Project	IEEE 802.16 Broadband Wireless Access Working Group < http://ieee802.org/16 >	
Title	Revised Chapter 1	
Date Submitted	2006-01-11	
Source(s)	<p>Jose Puthenkulam Intel Corporation 2111 NE 25th Ave. JF3-336 Hillsboro, OR 97124</p> <p>Philip Barber Zou Lan Fu Yan Huawei Technologies</p>	<p>Voice: (+1) 503 521 1812 Fax: (+1) 503 264 4254 Email: jose.p.puthenkulam@intel.com</p> <p>Email: zlan@huawei.com</p>
Re:	Call for Comments 80216g-05_013.pdf and Baseline Document 80216g-05_008r2.pdf	
Abstract	Revised Text by moving content from Chapter 14 to Chapter 1.	
Purpose	Proposal for adoption as new baseline text by Netman task group	
Notice	This document has been prepared to assist IEEE 802.16. It is offered as a basis for discussion and is not binding on the contributing individual(s) or organization(s). The material in this document is subject to change in form and content after further study. The contributor(s) reserve(s) the right to add, amend or withdraw material contained herein.

Revised Chapter 1

A.1. Proposed Text Changes

Figure 1—IEEE Std. 802.16 Protocol Architecture Model

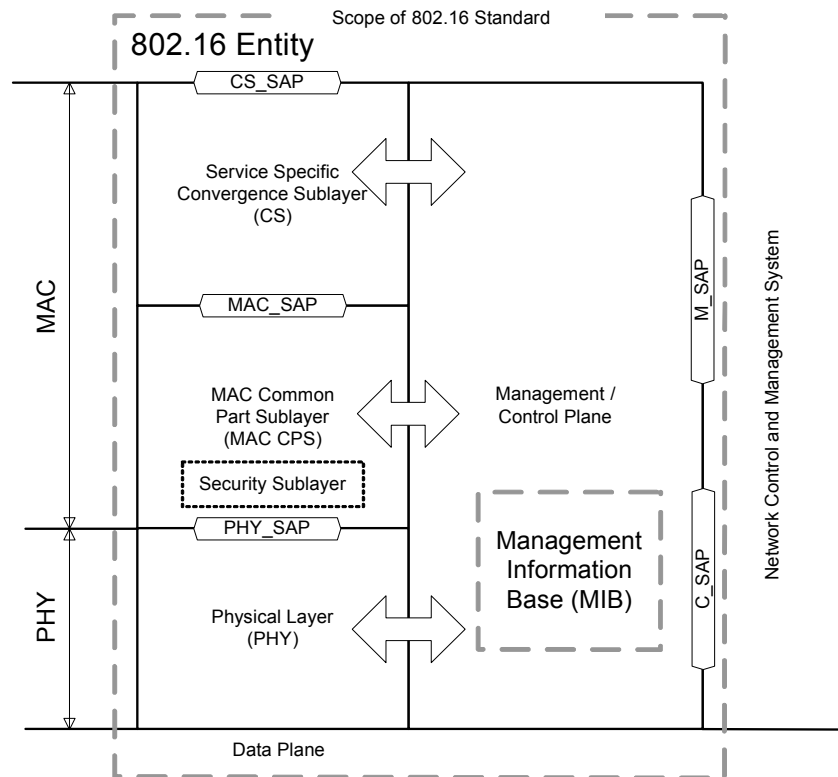
Figure 304 moved here from 802.16g-05_008r2 Section 14.4 and is revised as Figure 1

[Replace the figure 1 in section 1.4 with the one below]

Figure 1a—Illustration of the Network Control and Management System (Informational)

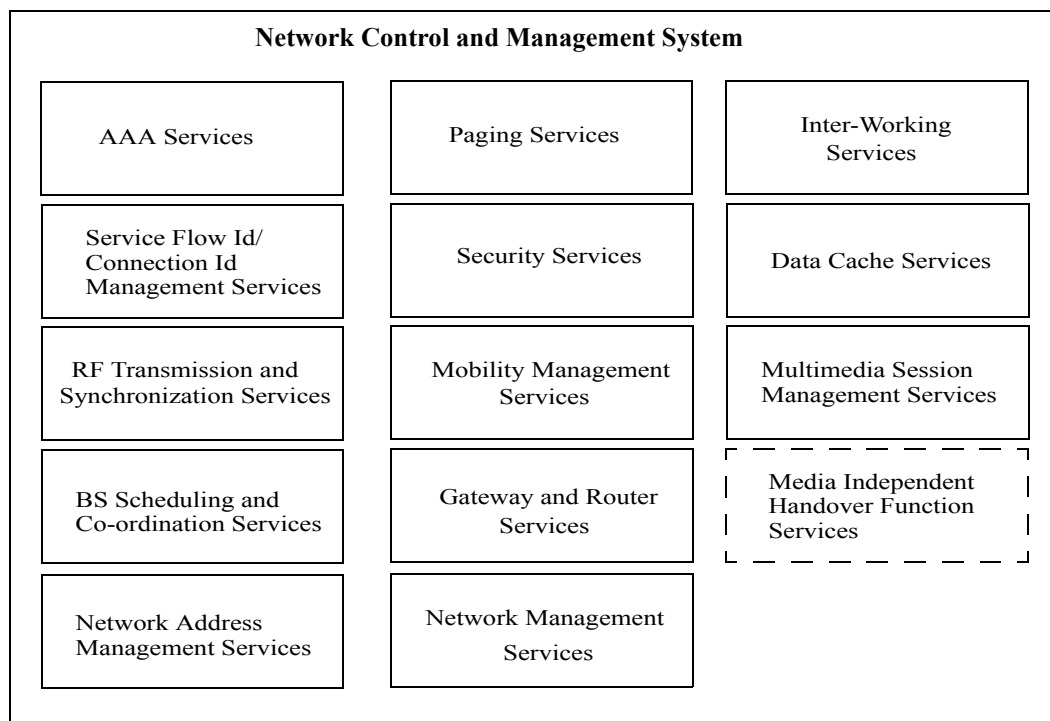
This abstraction is detailed in Figure 1a to show the different functional entities that make up such a Network Control and Management System. These entities may be centrally located or distributed across the network. The exact functionality of these entities and their services is outside the scope of this specification but shown here for illustration purposes and to better enable the description of the management and control procedures.

Figure 1b—802.16g Network Reference Model

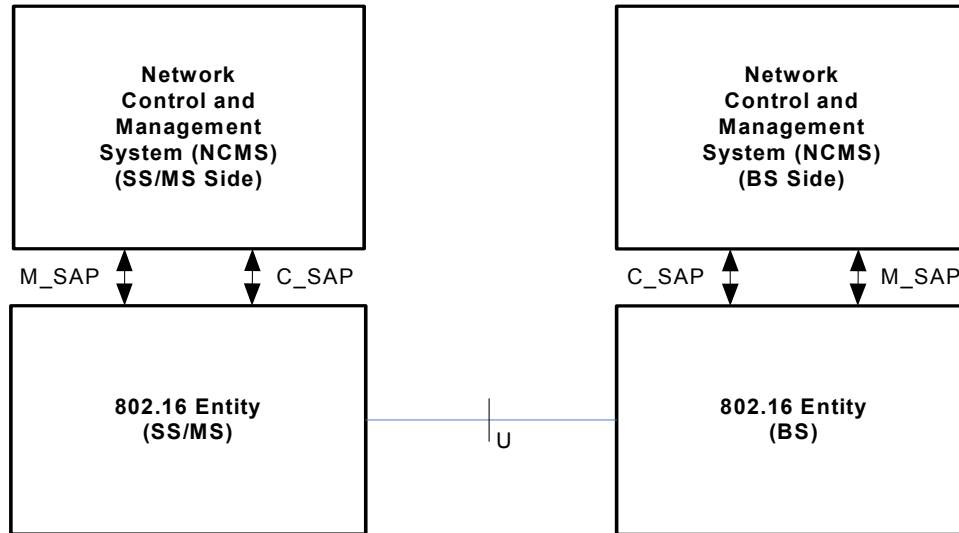
The Figure 1a describes a **simplified** network reference model. ~~along with the interfaces that are within the scope of this specification.~~ Multiple SS or MS maybe attached to a BS. ~~The SS communicate to the BS over the U interface using a Primary Management Connection or a Secondary Management Connection. MS typically only utilize the Primary Management Connection over the U interface for management and related control functions: SS or MS communicate to the BS over the U interface using a Primary Management Connection, a Basic Management Connection or a Secondary Management Connection.~~
